| DOOSAN **Document Transmittal**<br>Upper Trishuli-1 HEP (216MW) | Date<br>2022-02-28 | DT No.:<br>UT1-HEP-DHI-PC-D-0002 | SHEET<br>1 OF 1 |
| SUBJECT | Review Note RN-0060_Outline of Diversion Tunnel Intake Tower | | |

## REVIEW NOTE

| Title of the Document | Outline of Diversion Tunnel Intake Tower | | |

| BLOCK | DRAWING NUMBER | SHEET NO. | REV. NO. |
|---|---|---|---|
| A | UT1-C-010-CVL-DG-42008-1 | 1 OF 3 | 0A |

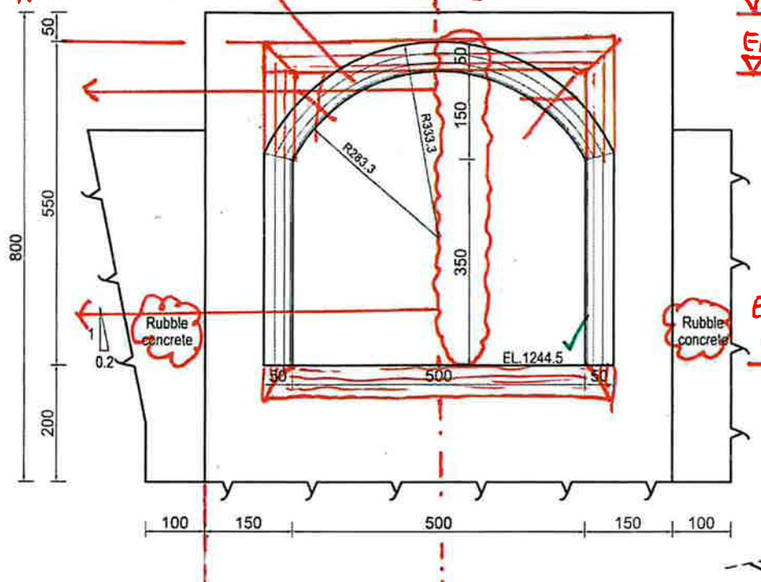
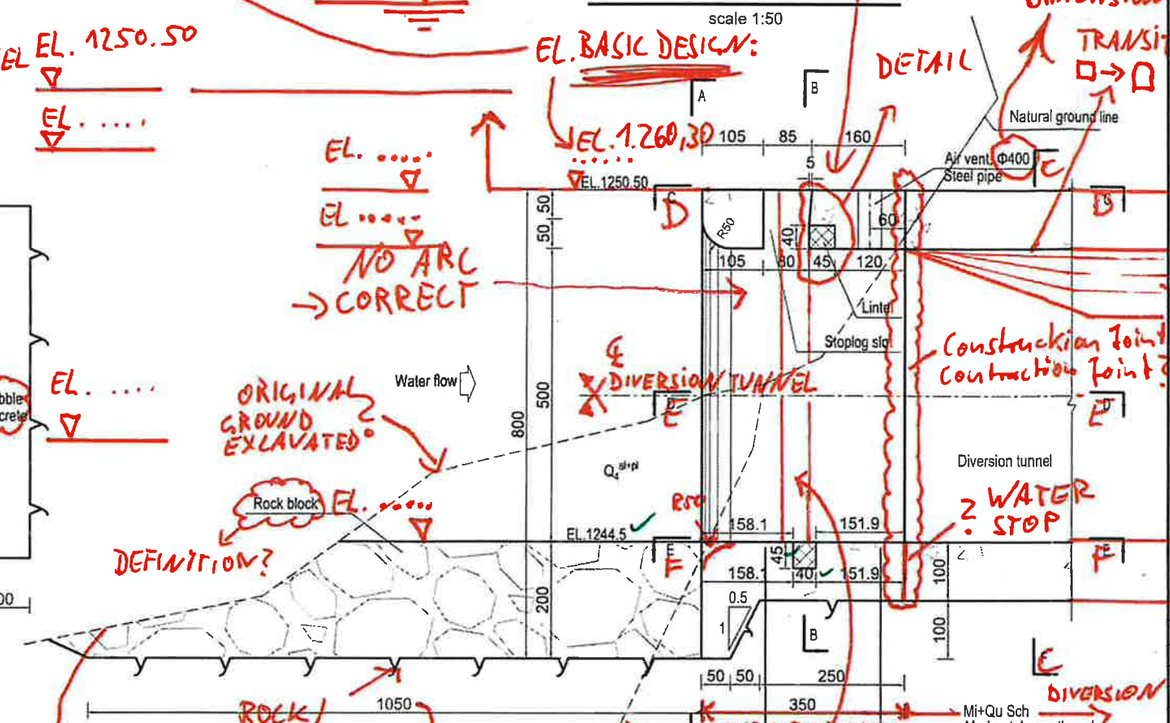
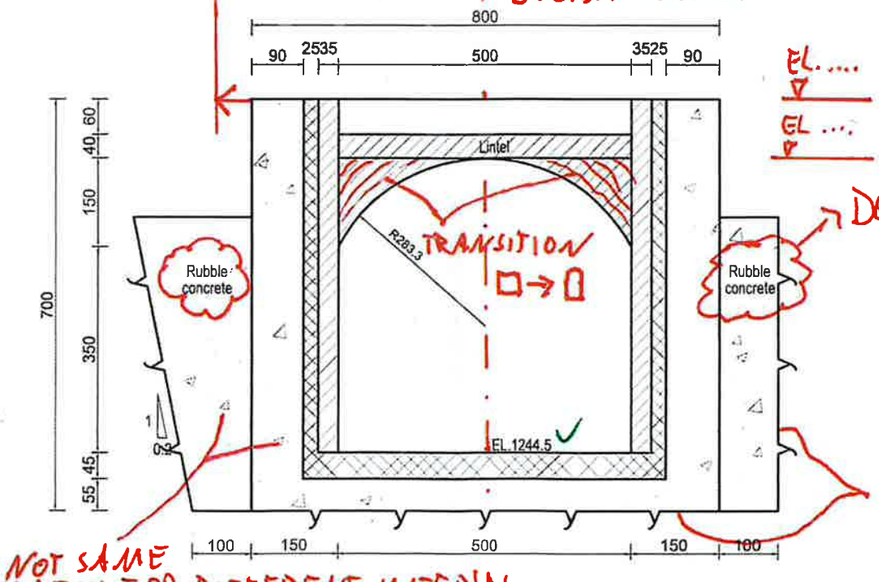
PLATFORM NOT TO BE SUBMERGED !!

MAX. WATER LEVEL

• ACCESS TO PLATFORM?

Platform: Dimension? allow to set stoplogs & PLATFORM FOR MOBILE CRANE? DIMENSION?

NO "ARC-CROSSSECTION" AT BEGINNING! SEE LONG SECTION → TRANSITION AFTE GATE!

STRUCTURAL ANALYSIS?

DESIGN OF: UT1_C_DFDR_011 TO BE CONSIDERED _012

? FA

NOT IN CODIFICATION

| INDEX | DRAWING NUMBER | SHEET NO. | REV. NO. |
|---|---|---|---|
| A | UT1-C-010-CVL-DG-42008-2 | 2 OF 3 | A |

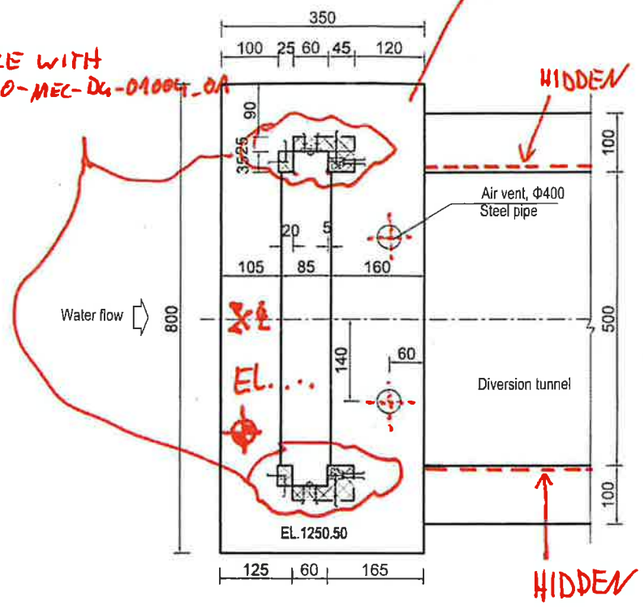
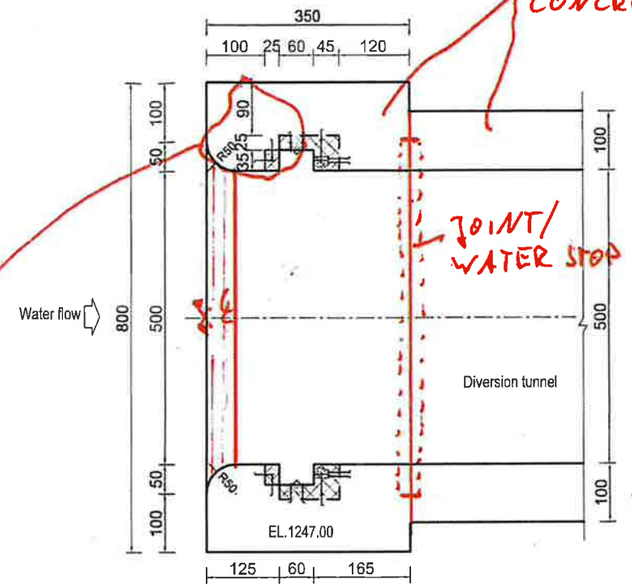
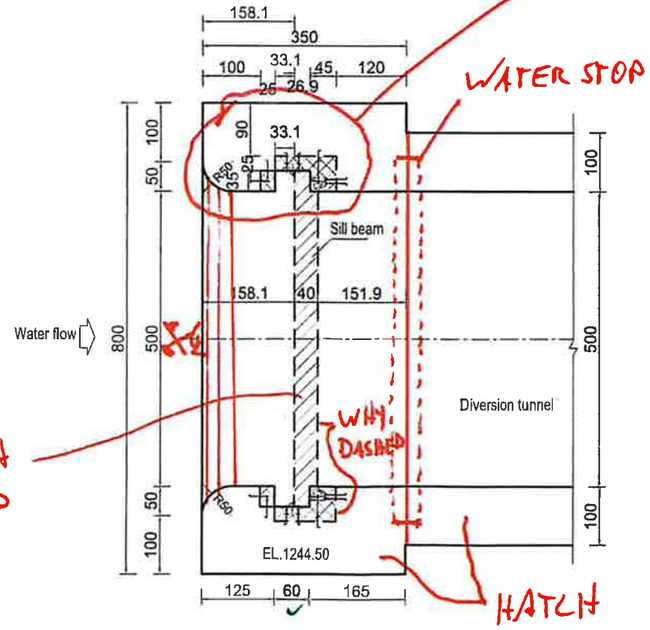
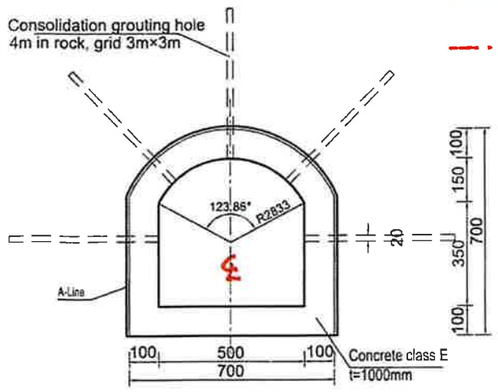
DIMENSION OF PLATFORM → MOBILE CRANE TO SET STOPLOG ?

COMPARE WITH UT1-N-010-MEC-DG-01006_0A

COMMENTS OF SHEET 1 ARE APPLICABLE

DETAIL DRAWING SEE E.G. UT1-N-010-MEC-DG-01004

WHY DASHED

| INDEX | DRAWING NUMBER | SHEET NO. | REV. NO. |
|---|---|---|---|
| A | UT1-C-010-CVL-DG-42008-3 | 3 OF 3 | 0A |

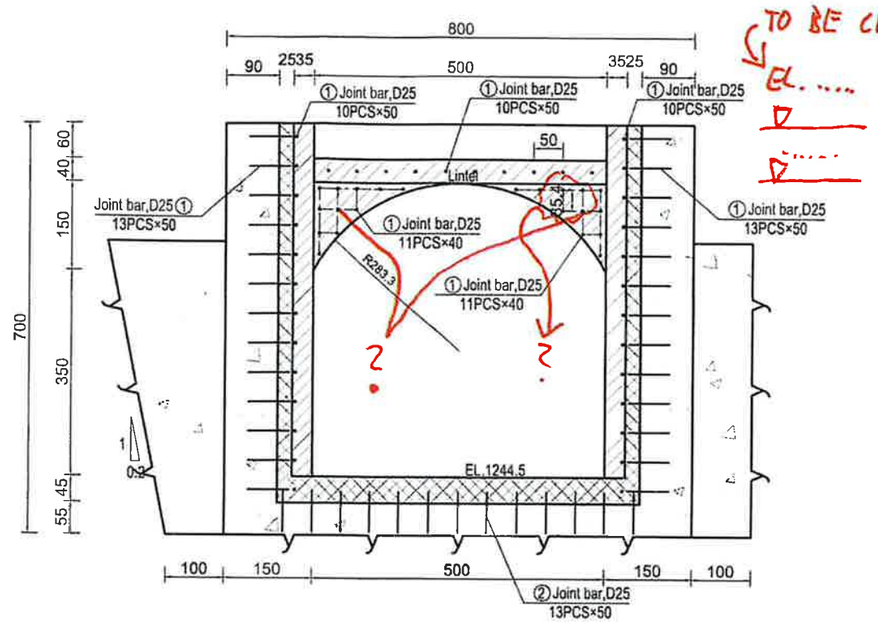
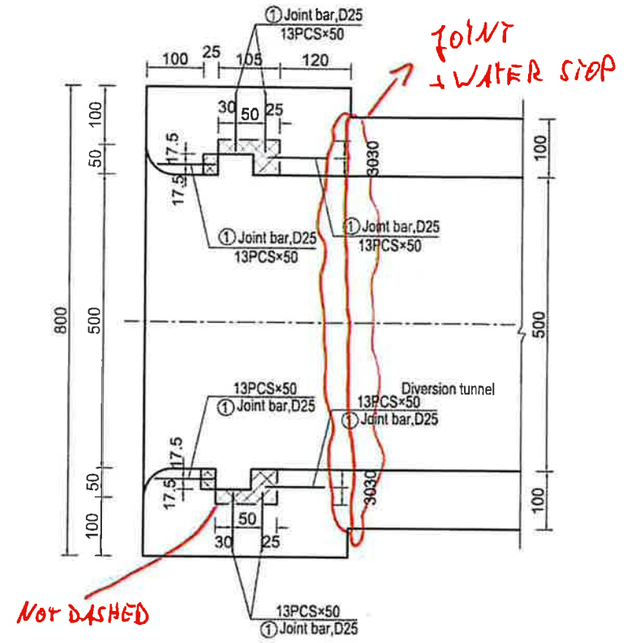
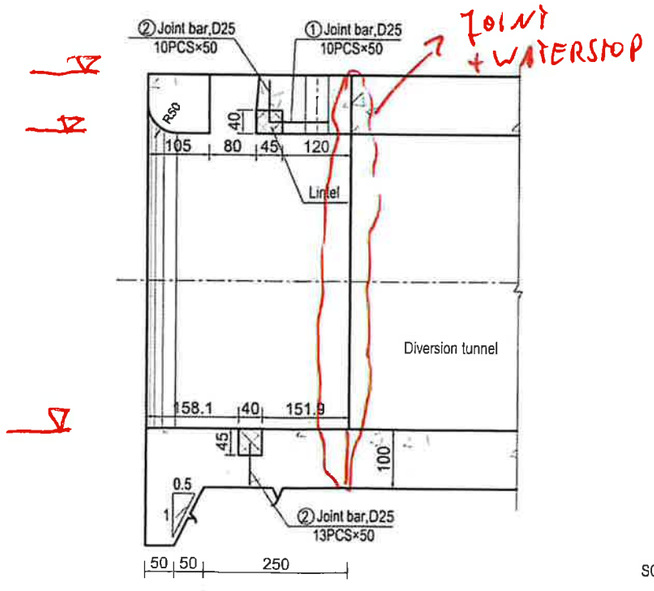
TO BE CHECKED
EL. ....

JOINT + WATER STOP

NOT DASHED

- PLACING OF JOINT BARS
- PLACING OF 1st STAGE EMBEDDET PARTS
- RE-BARS
- → VERIFICATION OF MAX. CONCRETE AGGREGATE SIZE?
- → COMPACTION OF FRESH CONCRET? VIBRATION/ SELF COMPACTION

COMMENTS OF SHEET 1 ARE APPLICABLE
